### **4. Stapel Subdivision; KPB File 2026-076**

#### PLAT OF STAPEL SUBDIVISION

**ITEM #4 - PRELIMINARY PLAT  
STAPEL SUBDIVISION**

**STAFF REPORT**

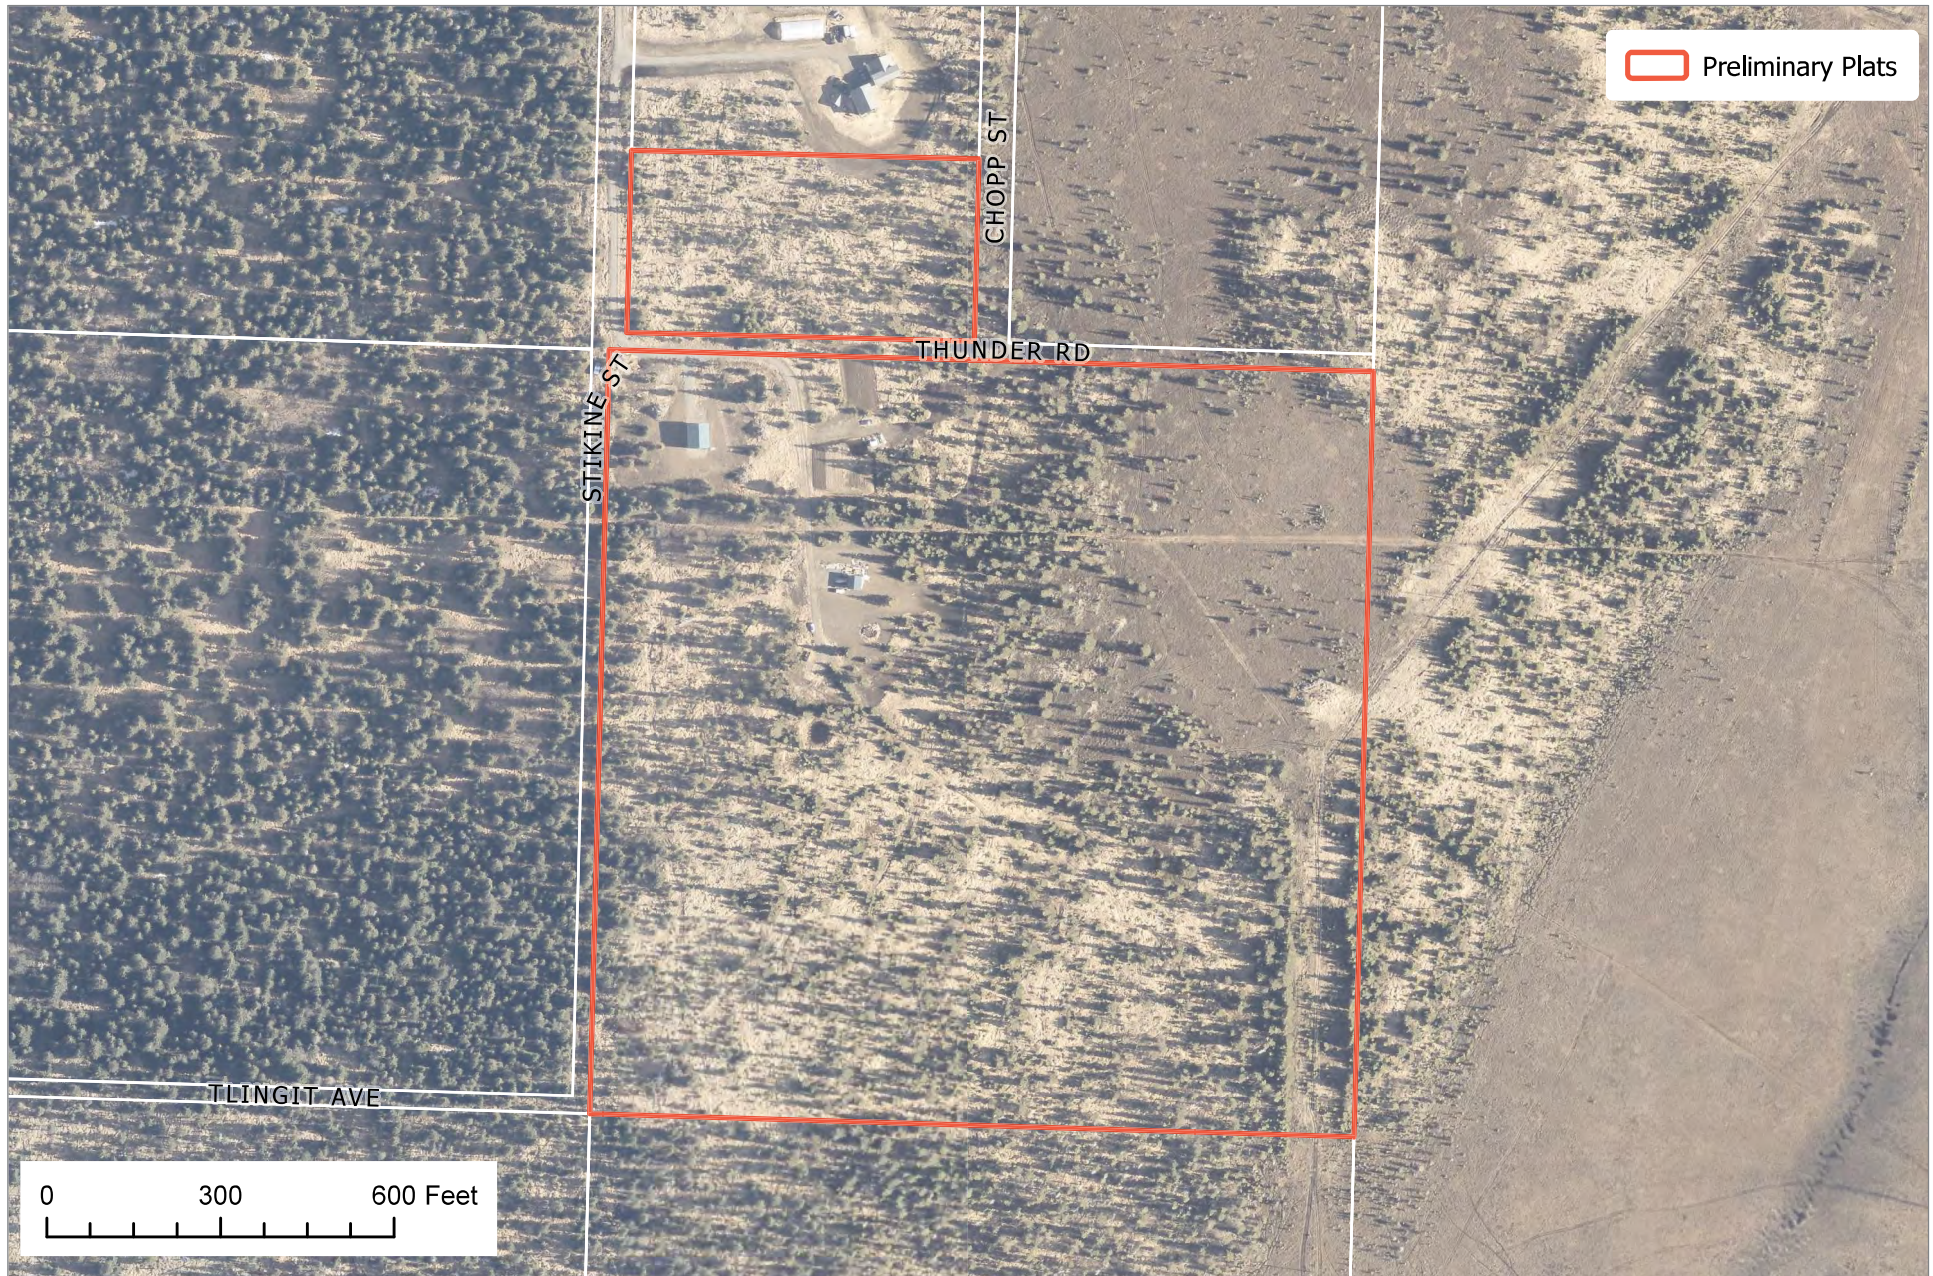
On the north the plat is dedicating 30' for Thunder Rd and adjusting around an existing high tower (garden infrastructure) located on the north side of proposed Lot 2. The Roads Director has requested the design of the curves be adjusted to fit code better (see comment below)

**Staff recommends** the surveyor apply for an exception to the 20' building setback since the structure is landing within it when the new adjustments to the dedication are made.

There is a drive accessing the property going to a house on proposed Lot 3. Surveyor should note if there is in place or if there are plans for a private access easement along the driveway.

| KPB Roads Dept. comments | Out of Jurisdiction: No<br><br>Roads Director: Uhlin, Dil<br>Comments:<br>RSA objects to this design KPB Code 20.30.130(A) requires 100-foot tangent between curves. KPB Code 20.30.140 prohibits compound and broken-curves. |

|                  | We ask that the applicant increases the length of transition to satisfy code requirements. |

Add the date of August 10, 2026 to the Plat Approval

- o Plat name needs to include parent plat name. Suggest Whiskey Gulch Stapel Subdivision
- o Modify the KPB File No to 2026-076

- o Depict and label Granross Creek

Flood Hazard Notice add as plat note 6 additional info from river center review
